ZONING CHANGE REVIEW SHEET

CASE: C814-2023-0057 (200 E. Riverside PUD) DISTRICT AREA: 9

ADDRESS: 200 East Riverside Drive

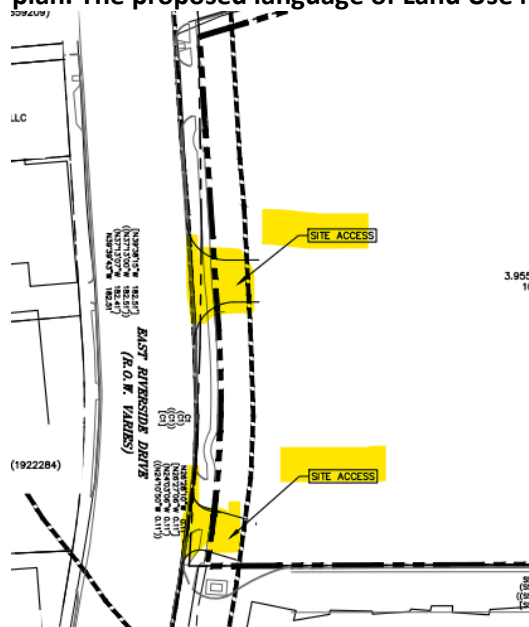
U2: Comment pending. The TIA final memo states the following:

8. Approval of this TIA does not grant nor guarantee approval of proposed driveway locations or driveway types. An updated TIA or addendum may be required at the time of the site plan when more details about the site are available.

Accordingly, please remove any reference to site access points from the PUD exhibits or note that they are only demonstrative and subject to review at the time of site plan. The proposed language of Land Use Note #1 should be modified to reflect this.

Figure 2: Barton Springs Road Extension Cross Sections

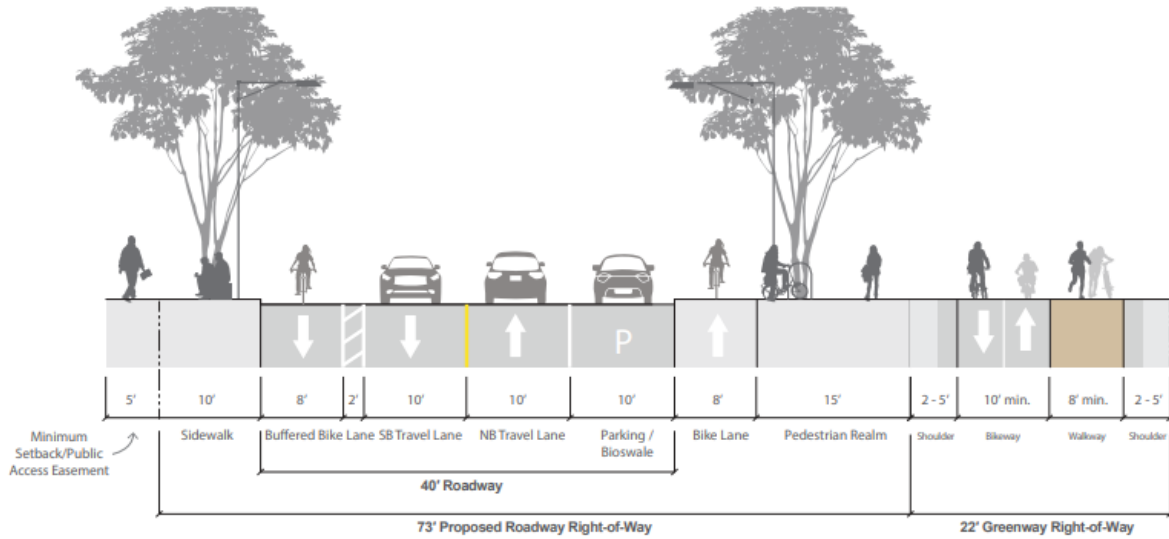
ATD 9. Additional Comments:

17. THE PUD WILL BE FOCUSING ON SIGNIFICANT IMPROVEMENTS FOR PEDESTRIAN AND BICYCLE ACTIVITY FROM EAST RIVERSIDE DRIVE TOWARD LADY BIRD LAKE IN COORDINATION OF PROJECT CONNECT AND AUSTIN TRANSIT PARTNERSHIP. THE IMPROVEMENTS WILL BE ON THE WEST SIDE OF THE PROPERTY WITH CONNECTIVITY TO THE PARKLAND DEDICATION AREA ON THE ADJACENT PROPERTY TO THE NORTH. THE IMPROVEMENTS WILL PROVIDE CLARITY IN BOTH WAYFINDING AND GREATER PEDESTRIAN AND BICYCLE TRAFFIC SAFETY WITH CLEARLY DELINEATED PATHWAYS.

TPW recommends that the PUD specify these improvements by offering deference to the South Central Waterfront Plan, specifically the 22’ “greenway” and/or the desired cross-section as identified by Project Connect when available:

- U1: Comment pending TPW comment #6.
- U2: **Comment pending. Land Use Note #24- at this time it is unclear how these “improvements” will be above and beyond the base line requirements of the TCM. Please clarify what these improvements may entail and add the language “subject to approval from Director” to the proposed note.**
